On December 21, 2023, GTI Energy prepared a memo titled "EHP vs GHP Methodology for Washington Gas Maryland Gas Heat Pump Pilot" ("GTI's December memo") on behalf of Washington Gas Light Company (WGL). GTI's December memo describes GTI's proposed methodology to conduct a comparative analysis of a gas heat pump (GHP) and an electric heat pump (EHP) with regard to WGL's Gas Heat Pump (GHP) Pilot program, in response to Maryland Public Service Commission (PSC) Order No. 90663. In particular, this PSC order requires the following under Section 12:

The Maryland Office of People's Counsel requested that Synapse review GTI's December memo. As noted below, as well as during the February 21, 2024 EAG Work Group meeting, GTI's proposed method lacks key costs and benefits to comprehensively

Figure 1. Brattle Study heat pump space heating COP curves

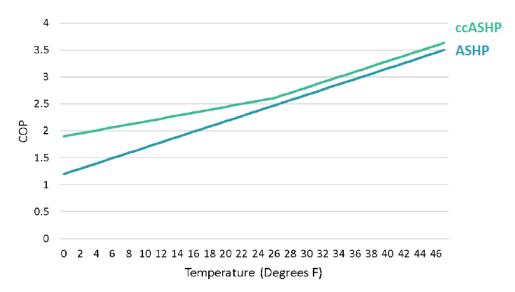
We estimated average COP values using Brattle's COP curves for Maryland to assess the reasonableness of GTI's proposed heating efficiency ratings for EHPs. More specifically, we applied the COP curves to hourly weather data (the typical meteorological year 3 data or TMY3 data) specific to Montgomery County, Maryland to estimate COP values.⁷ The resulting average COP values are 3.3 for a cold climate EHP and 3.1 for a regular EHP. These values can be translated into 11.2 HSPF2 and 10.7 HSPF2, respectively, if we convert these values based on a pure physical unit conversion.⁸ These values are approximately 40 percent greater than the HSPF2 ratings GTI Energy proposed.

We recommend that GTI use Brattle Electrification Study's COP performance curves and Maryland-specific hourly temperature data to estimate the performance of EHPs because (a) these performance curves reflect real-world performance of numerous heat pumps and because (b) they were already vetted and approved by the ESWG for the Brattle Electrification Study. Further, we recommend that GTI collect additional data from the other EmPOWER utilities as directed by the Commission in Order No. 90663. Such local

Figure 3. UEF ratings for 240-volt Energy Star HPWHs

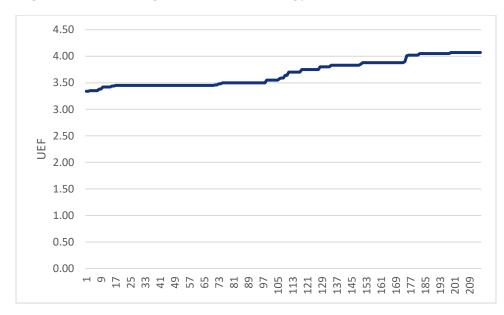
Third, 120-volt HPWH units recently have become available in the market and the number of available models is only about one-fifth of the number of standard 240-volt HPWH models available. Thus, it may make sense to develop and use a UEF value based on 240-volt models or an average of the two types of technologies. There are currently 215 Energy Star HPWH models that use 240 volts. The UEF values for 240-volt HPWH models are considerably higher than the values for 120-volt models and range from 3.3 to approximately 4.1, with an average UEF of 3.7 (Figure 3 below).

Lastly, it is important to note that the Brattle Electrification Study assumes a COP of 3.3 for 2022 (which is equivalent to a UEF of 3.3) and a COP of 3.79 for 2031.¹¹ If GTI Energy cannot find any real-world performance data for HPWH, we recommend a UEF of 3.3 to be consistent with the Brattle study's assumption.
